ADDENDUM A
SOLICITATION #3450004900 / 20-FM-0042
01/31/2020

ODOT DIVISION V
BECKHAM COUNTY MAINTENANCE YARD
(SAYRE, OK)

This addendum contains corrections to the project specifications and plans.

Project: Oklahoma Department of Transportation – Beckham County Maintenance Facility
Location: Sayre, Oklahoma
Issued Date: 30 January 2020

C4.2

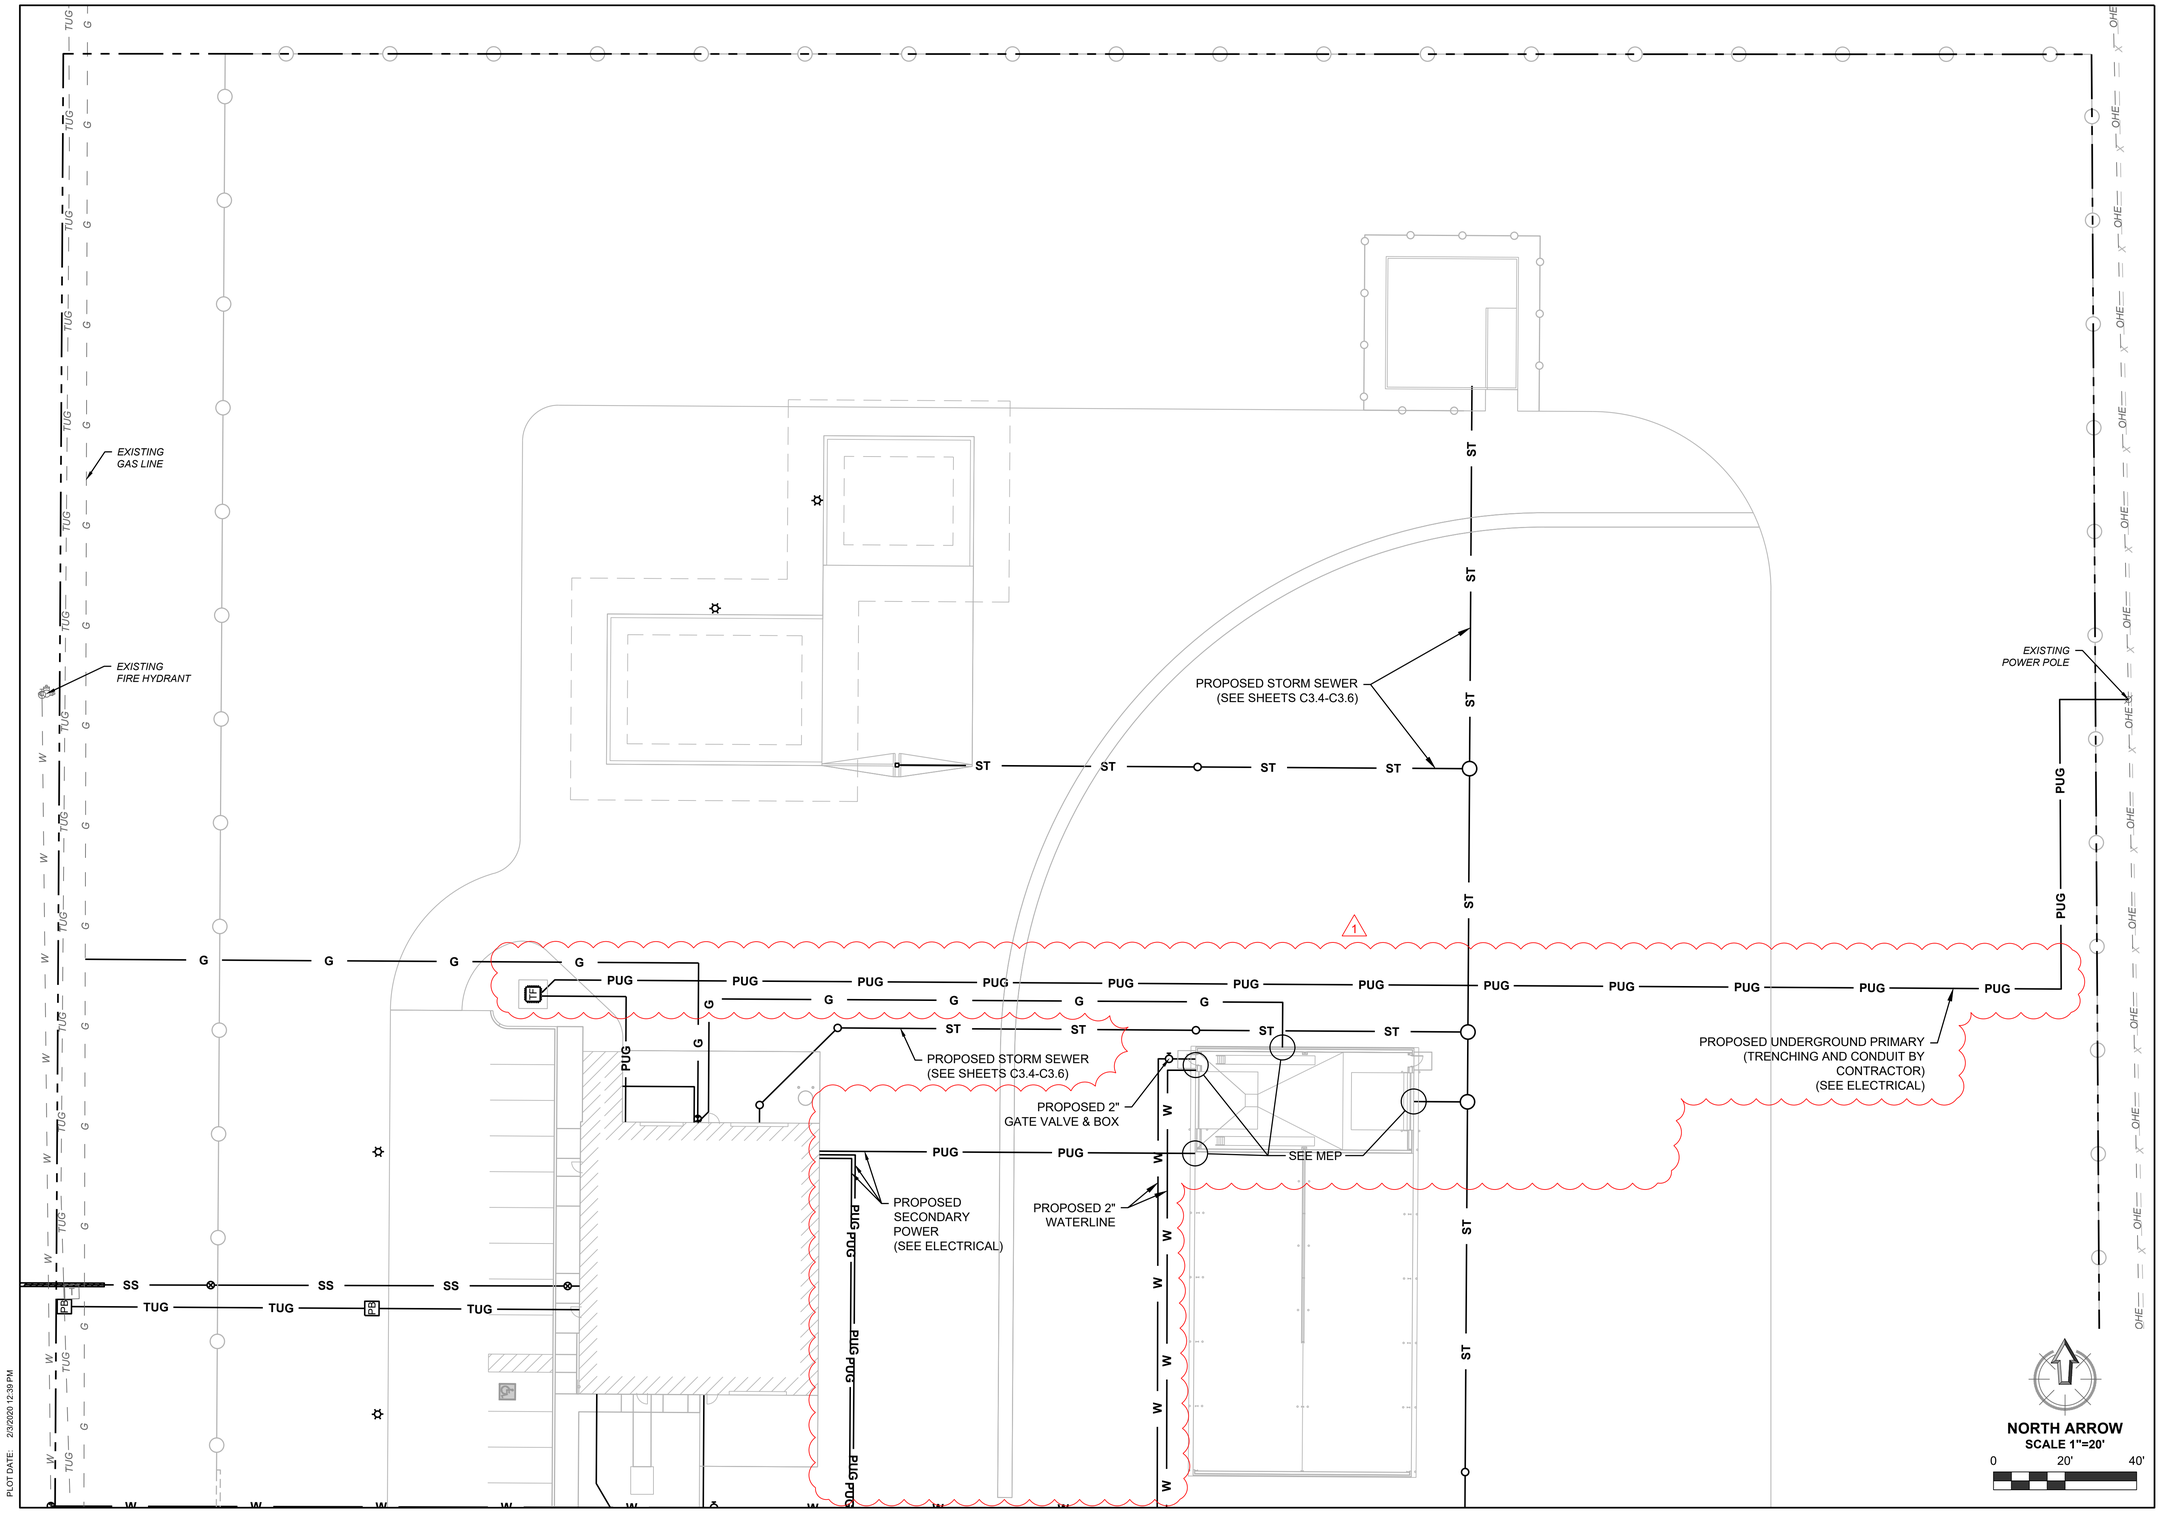
SHEETS C4.0, C4.1, C4.2, & C4.3 Replace sheets with attached; revised waterline sizes & added fill hydrant at hopper rack; revised electric pathways

SHEET
C4.4

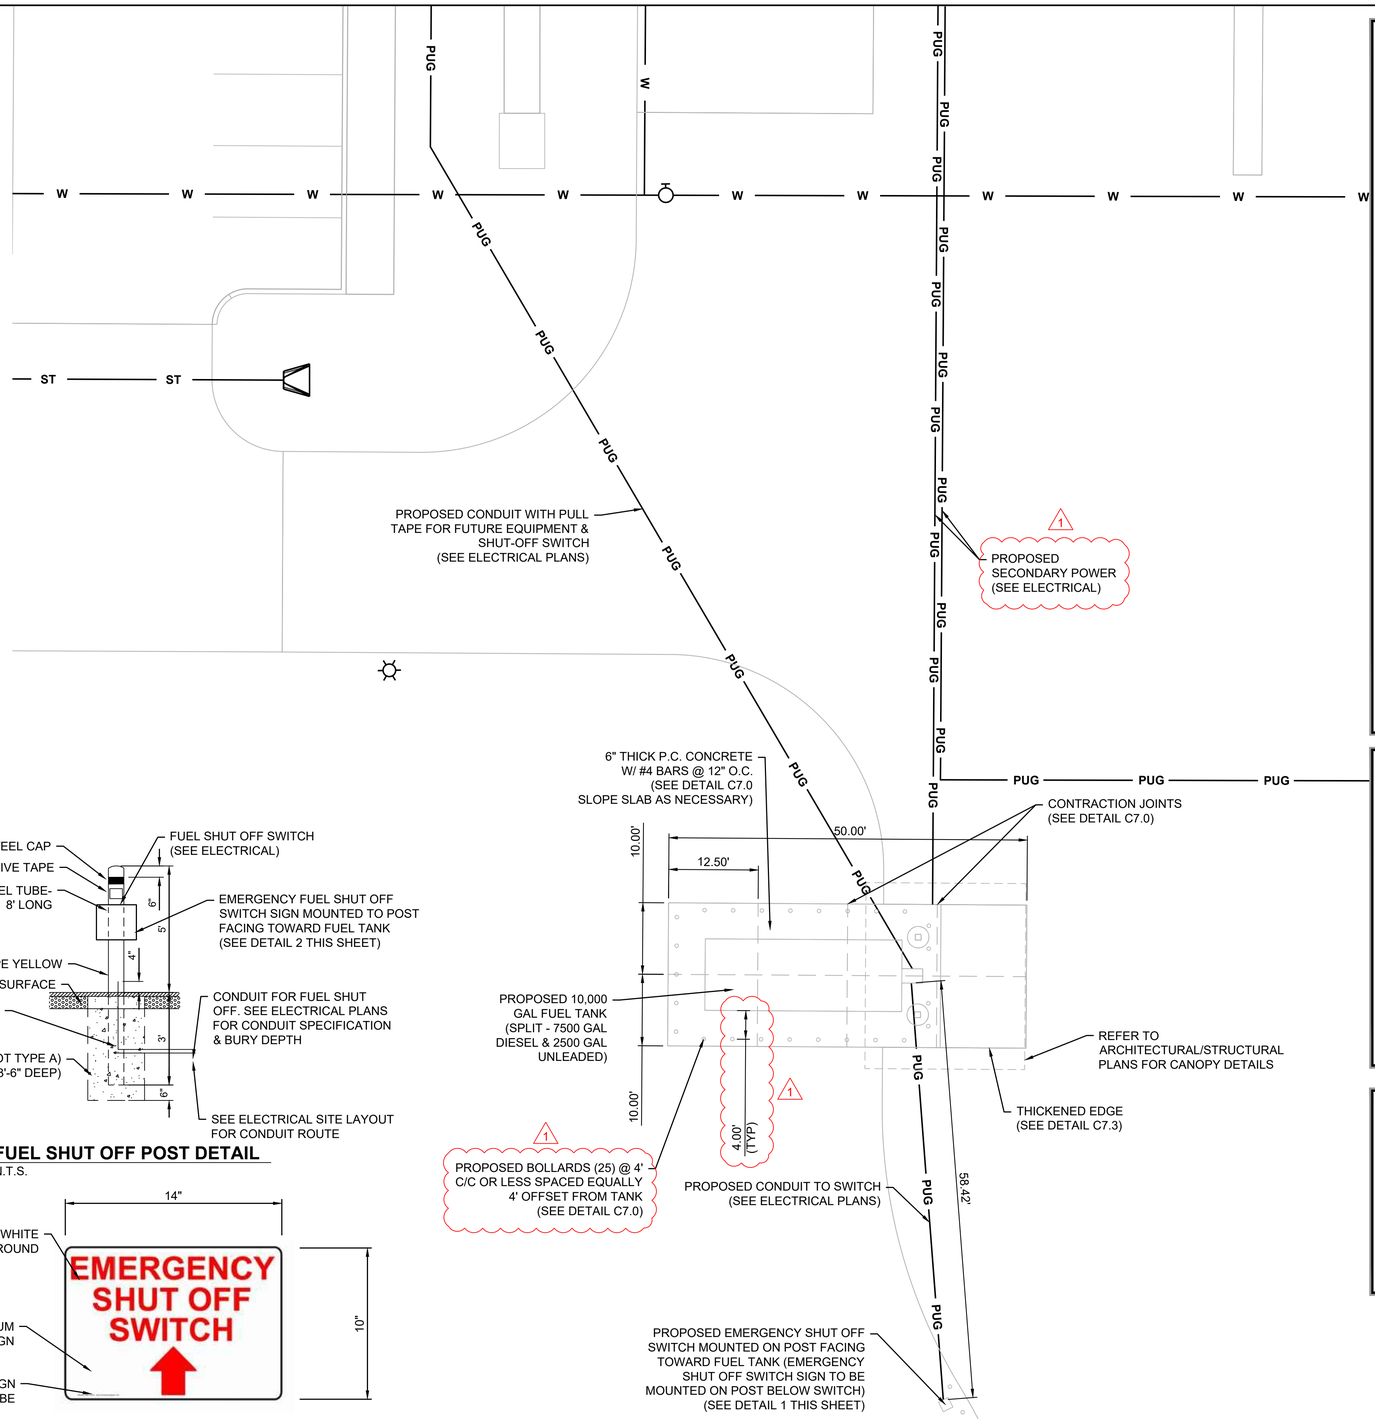
SHEET C4.4 Replace sheet with attached; additional bollards to meet OCC regulations

SHEET
C7.2

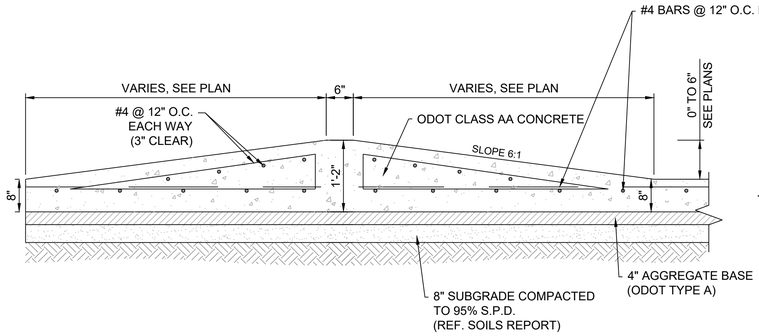
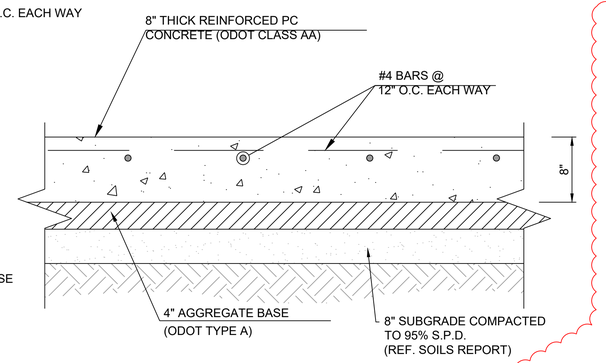
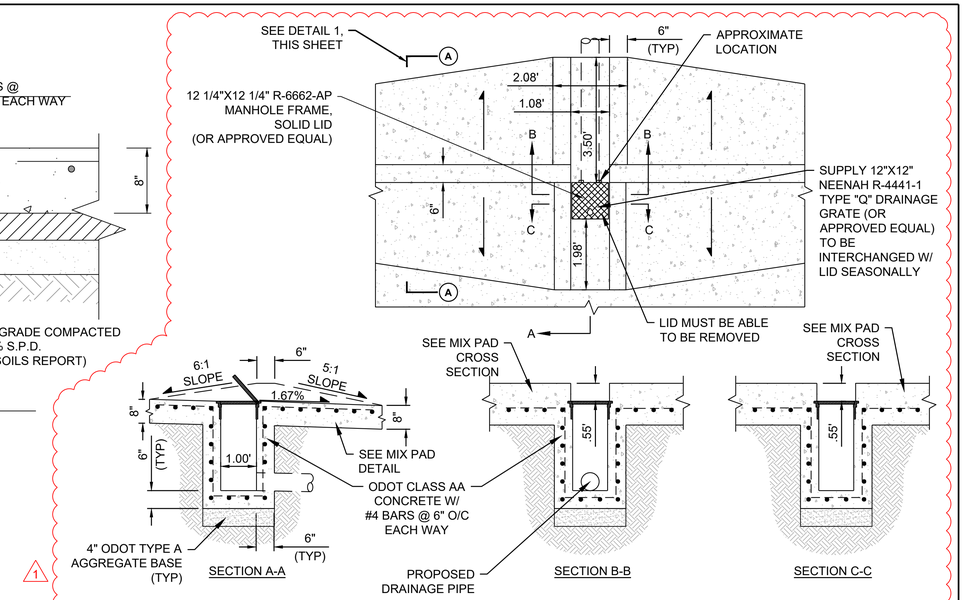
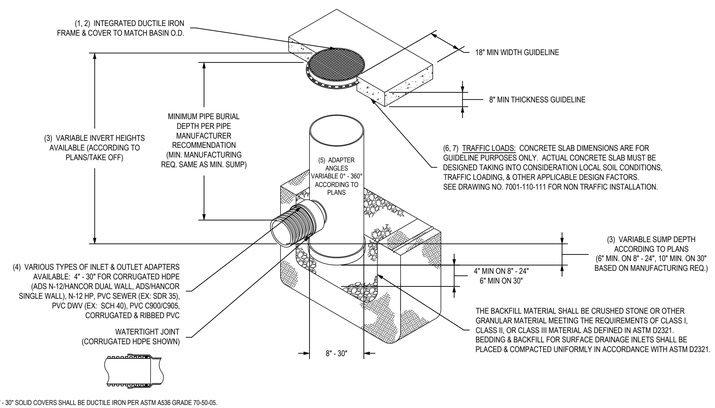
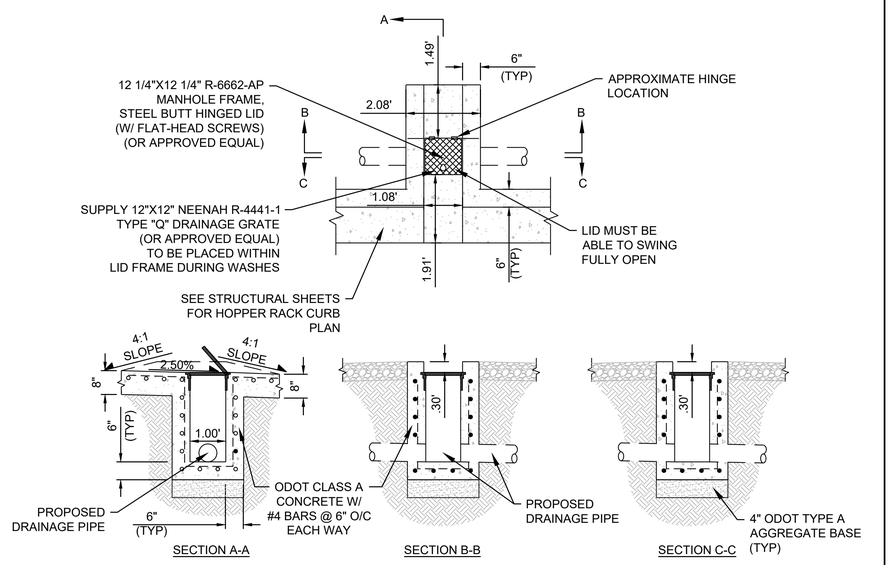
SHEETS C7.0, C7.1, C7.2, C7.3 Replace sheets with attached; added details for flexamat, fillet reinforcing, gore stripe, sidewalk expansion joint, & fill hydrant; revised details for mix pad inlet & tank pad

SHEET
G1.0

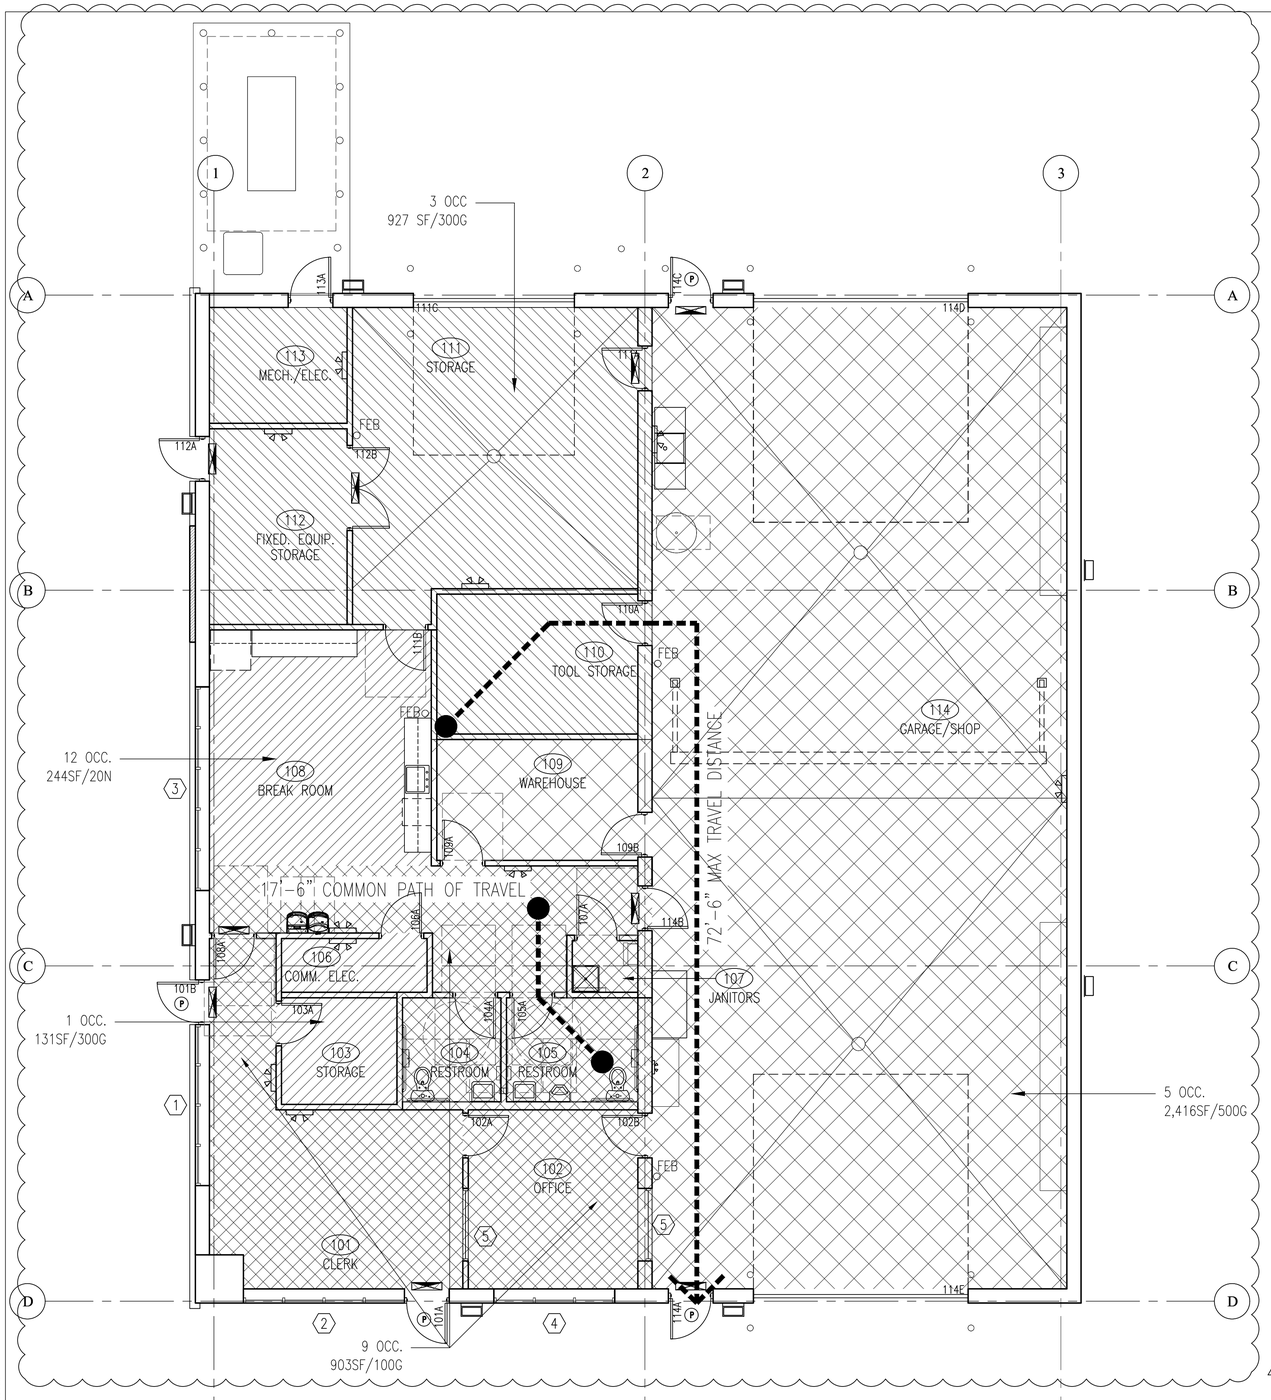
2.2 Modify the following Sheets:
- A. G1.0 – Added clarification to the code plan and legend, enlarging some symbols, and adding indications of locations of egress door panic hardware.
- B. MA2.0 – Added dimensions and notes to enlarged floor plan.
- C. MA3.0 – Added roof plan legend.

SHEET
MA4.0

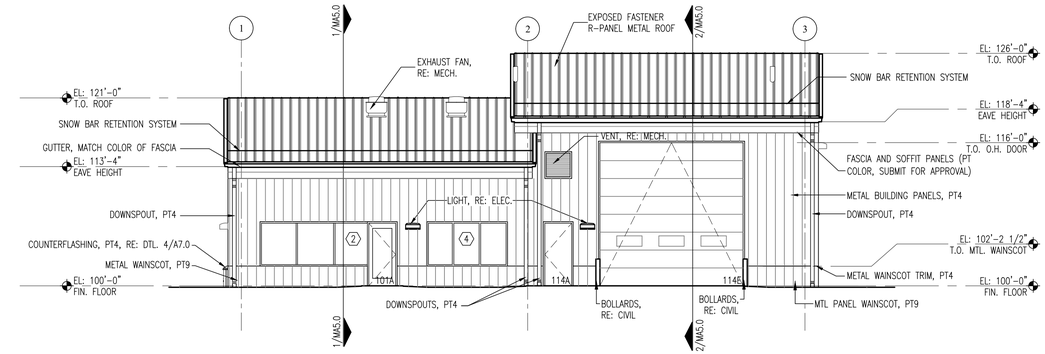
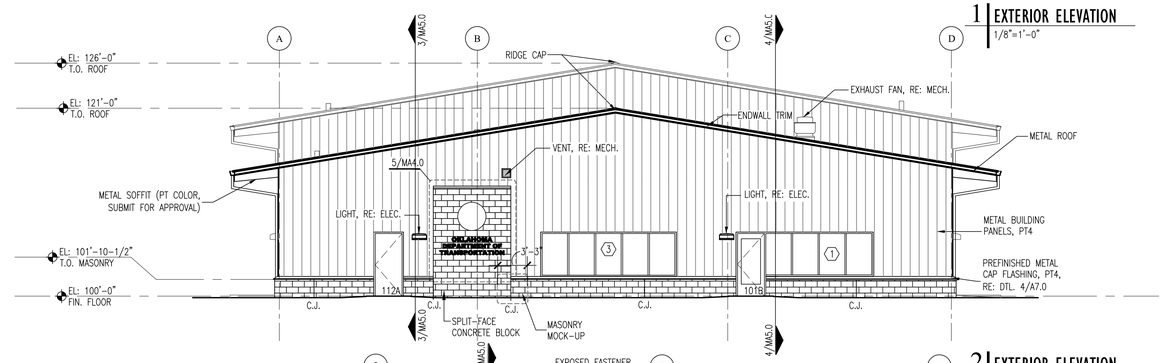
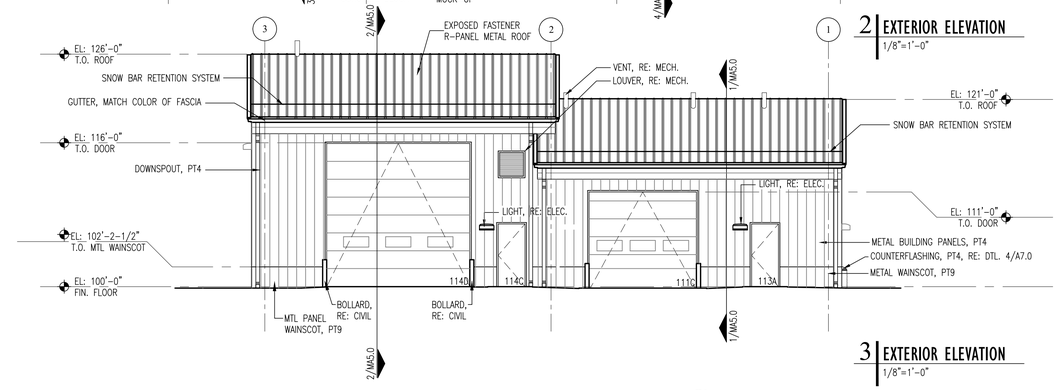
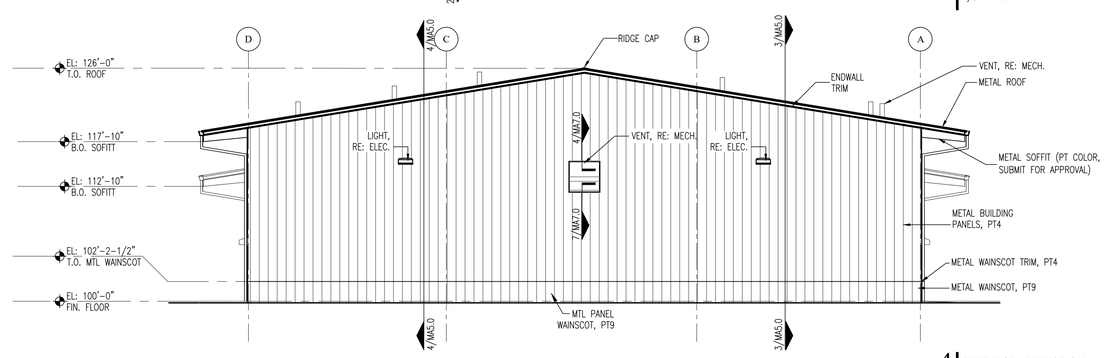
D. MA4.0 – Added elevation legend, added information on the roof snow guard spec. section, added information on roof type, added paint color for downspouts, clarified mechanical and electrical references.
